# Development Permit Appeal Application

David Stebbins "Stebbins Residence Project #51076"

- 1. Site Development Permit #389934
- 2. Coastal Development Permit #147134
- 3. Mitigated Negative Declaration #51076 approved by Planning Commission

APPEAL OF THE STEBBINS RESIDENCE PLANNING COMMISSION APPROVAL OF  
PERMITS AND MITIGATED NEGATIVE DECLARATION  
SAN DIEGO, CALIF.

OCEAN BEACH

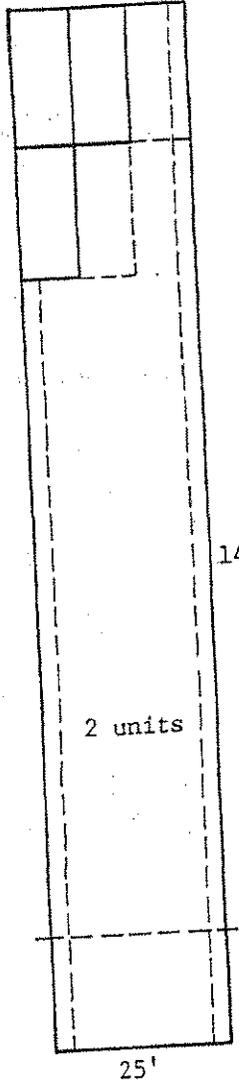
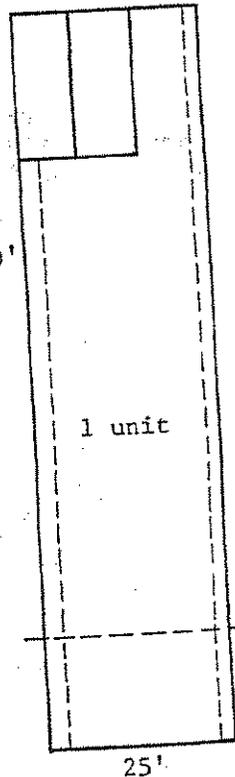
**Allowable building on lot size:** Page 116 of the OB Precise Plan (Attachment 3) describes the Stebbins residence exact lot size: 25 feet by 100 feet. This page also shows "probable development" for this lot as either 1 story/1250 square feet or 2 story/1750 square feet. Neither has underground parking. This page directly contradicts staff and applicant claims that he could not build a 1750 square foot residence unless he was granted the variance for underground parking in a flood plain. See also attachment 10 in which applicant architect asks City whether they will need to redesign without underground parking.
